GROUP	MODEL
	TRA	2023MY Niro P/HEV (SG2 P/HEV)
	NUMBER	DATE
	106	February 2023
TECHNICAL SERVICE BULLETIN		
SUBJECT: 6-SPEED DCT JUDGEMENT LOGIC IMPROVEMENT / GROUND BOLT TIGHTENING (P074A73)

This bulletin provides information to tighten both the clutch actuator and transmission control unit (TCU) grounding bolts then, upgrade the software logic of the 6-speed dual clutch transmission (DCT) on some 2023MY Niro P/HEV vehicles produced from June 14, 2022 through December 12, 2022, which may exhibit a poor shift quality concern and MIL 'ON' with DTC P074A73 stored. Follow the procedure outlined in this publication to tighten both the clutch actuator and TCU grounds, then upgrade the software logic of the 'A/T' system using the KDS ECU Upgrade function as described in this bulletin. For confirmation that the latest reflash has been applied to a vehicle you are working on, verify the ROM ID using the table on pages 4 and 5 of this bulletin.

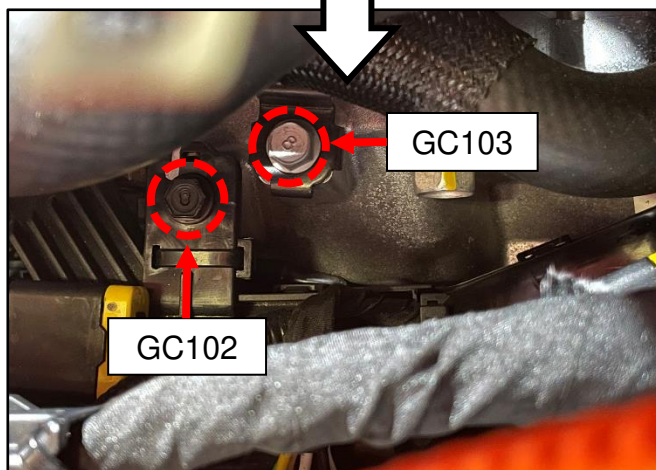
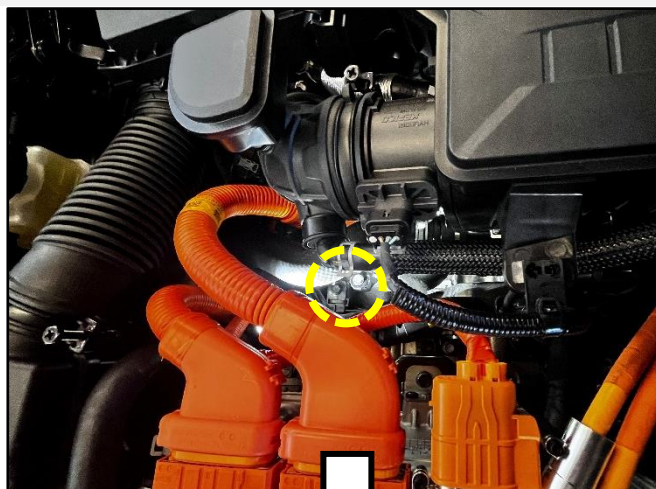
1. Using a 10mm socket with an extension, tighten the clutch actuator ground bolt (GC103) and TCU ground bolt (GC102).

Tightening torque for GC102:
5.8 - 7.2 lb.ft (7.8 - 9.8 N.m)

Tightening torque for GC103:
7.2 - 8.7 lb.ft (9.8 - 11.8 N.m)
